**Aceh & Nias Post
Tsunami
Reconstruction**

Review of Aceh Housing
Program

April 2006

Figure 2.6 Flood Prone Unstable Slopes, Sabang Island

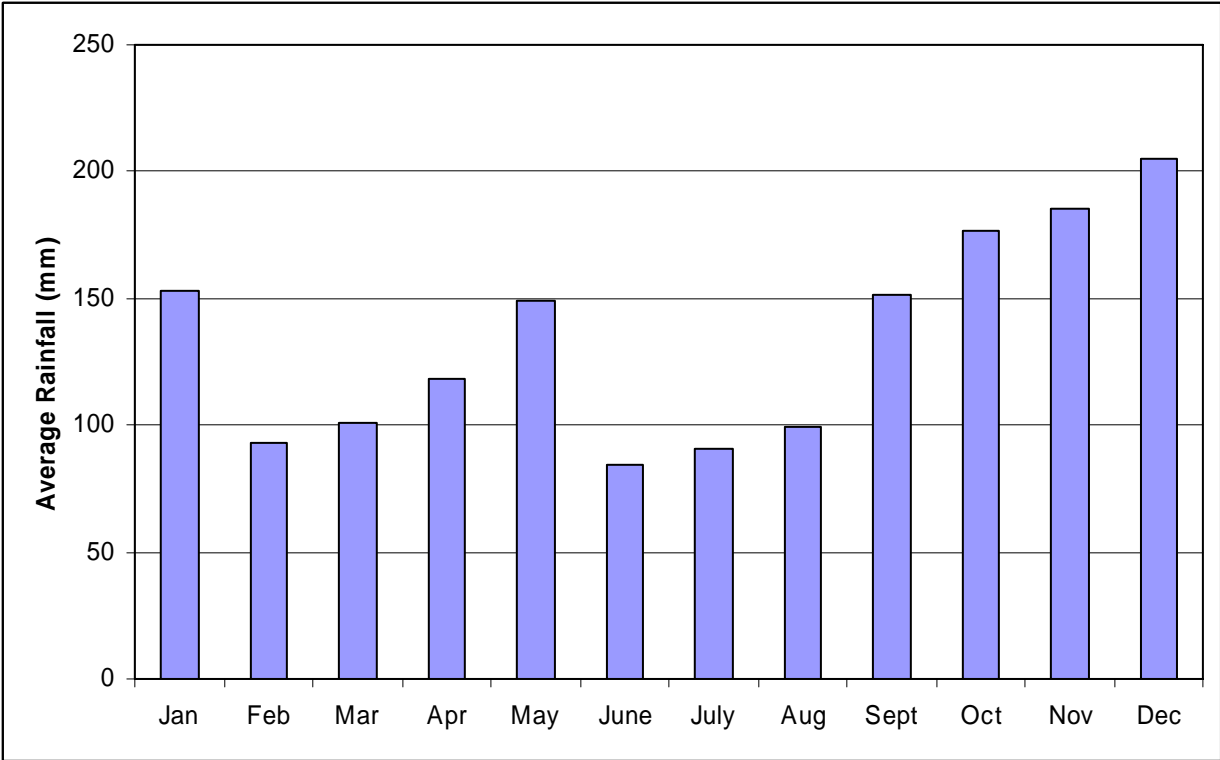
Where developments are to be built on slopes, it is important that terraces and drainage channels are sufficiently engineered to ensure their stability. Figure 2.6 shows two development sites on Sabang Island, where this has not happened. The first has already been subject to one significant landslide, whilst the second is considered to be highly unstable, due to the apparent uncontrolled manner of land clearance and subsequent earthworks. It is noted that the cost of properly designed engineering works to create suitable sites for housing development from steep hillsides, is very significant.

Beam to Column Connections (modified from Boen, 1978)**Ring Beam Connection (after Boen, 1978)****Figure 3.2 Typical Reinforcement Details**

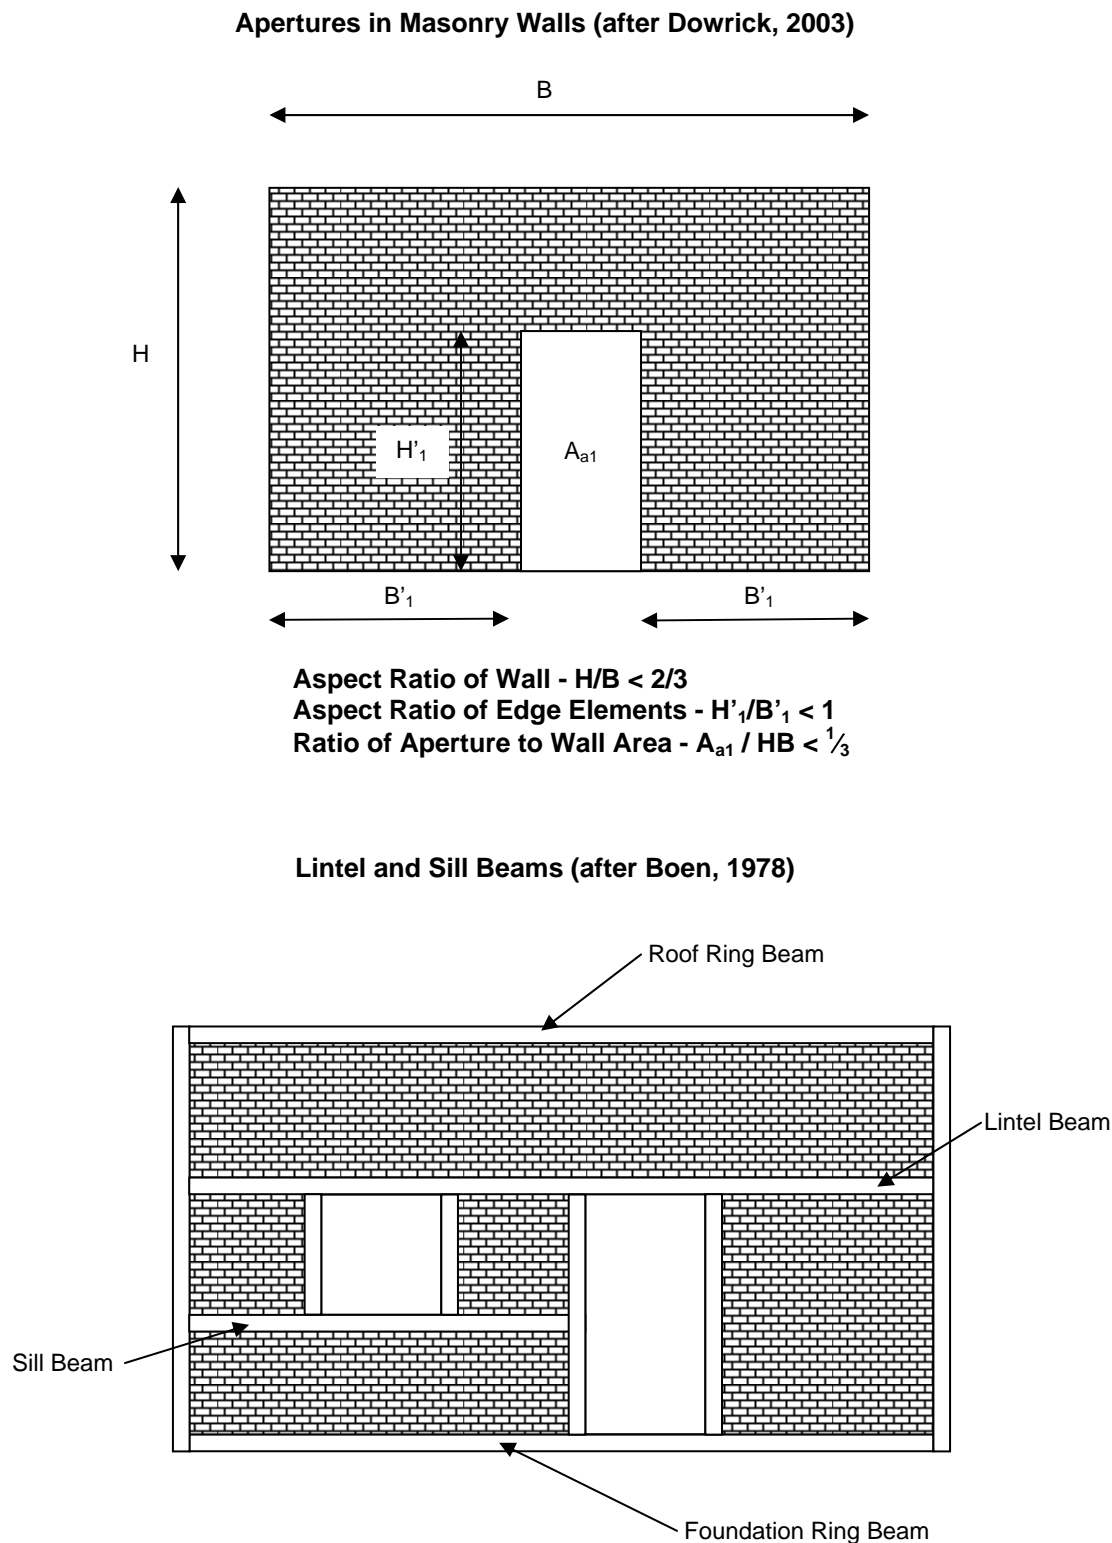
- Item 2 – Foundations should be constructed from concrete rather than rubble.
- Item 10 - Masonry details should show continuous sill or lintel beams below and above openings.
- Item 10 - Minimum sizes and spacing of openings in masonry panels should be provided.
- Item 11 - Reinforcement connection details between beams and columns should show L-bars to transfer loads between the elements in question.
- Item 18 - Masonry lintels are inappropriate in earthquake regions.

Alternative details for items 2, 10 and 11 are shown in Figures 3.2, 3.3 and 3.4.
